Panel Report

Surf Coast Planning Scheme Amendment C106

Planning Permit Application 15/0485

2 November 2016

Figure 2 Subdivision concept plan

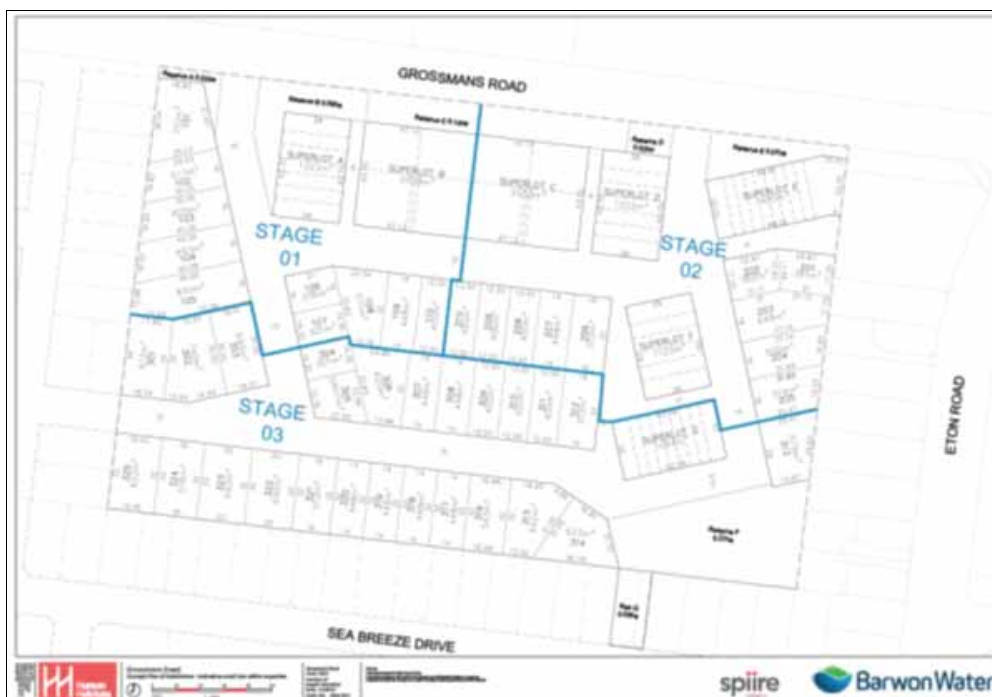
The subdivision concept plan is included at figure 2 and shows the creation of 52 residential lots, including 7 ‘superlots’, ranging in size between 301 to 2,059 sqm. The superlots will be developed with medium density housing.
